NOTICE OF PLAN COMMISSION MEETING

Re: Meadowview Dental – 544 Martineau Road
Stormwater & Site Plan Review #1
McM. No. C0006-09-26-00330.00

On April 9, 2026, McMahon Associates, Inc. (McMAHON) received a construction plan set for the proposed Meadowview Dental site submitted by Mach IV. As requested, McMAHON performed a review of these documents for conformance with Village standards, requirements, and preferences.

PROPOSED NEW BUILDING FOR:
 MEADOW VIEW DENTAL
 LOT 4 ON MARTINEAU ROAD, COMBINED LOCKS, WI
**EXISTING CONDITIONS /
 SITE DEMOLITION PLAN**

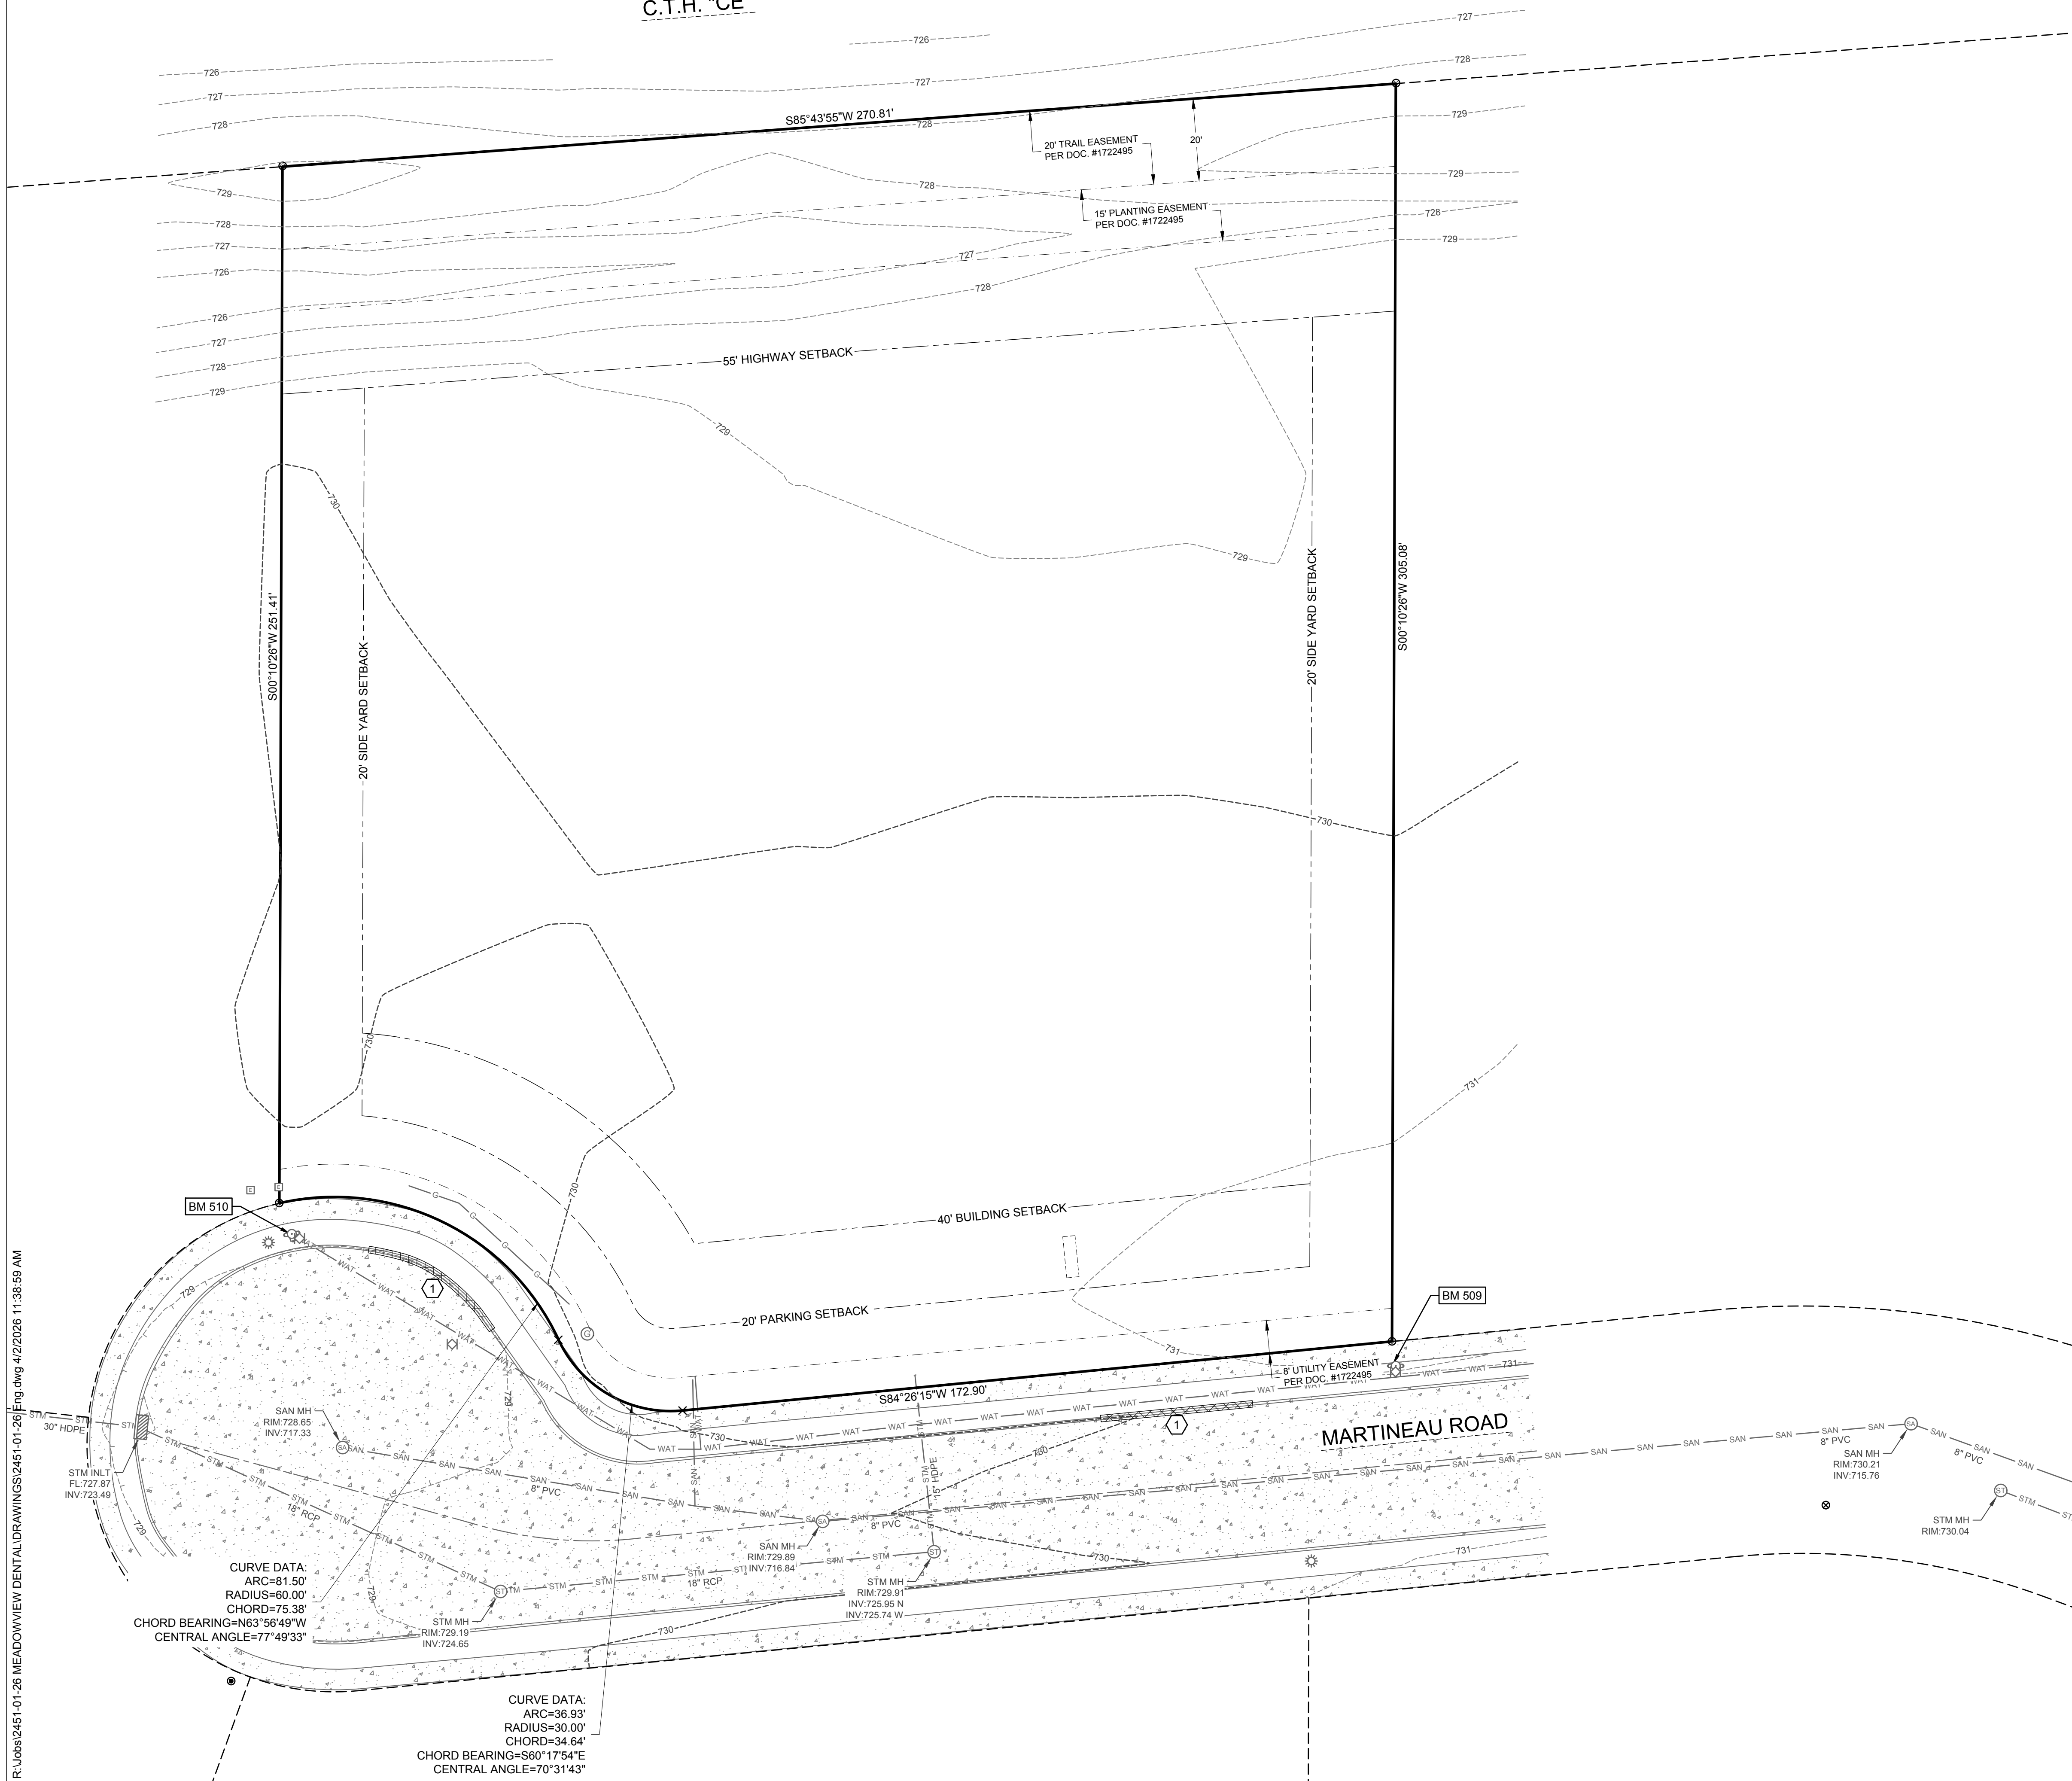
The proposed site demolition plan identifies sawcutting and removing the existing curb & gutter for the proposed driveways/aprons.

- The existing 4" thick sidewalk within the proposed driveway locations should also be identified to be removed. The site plan should show/call out the sidewalk being replaced with 6" thick concrete, similar to the new 6" thick concrete apron.
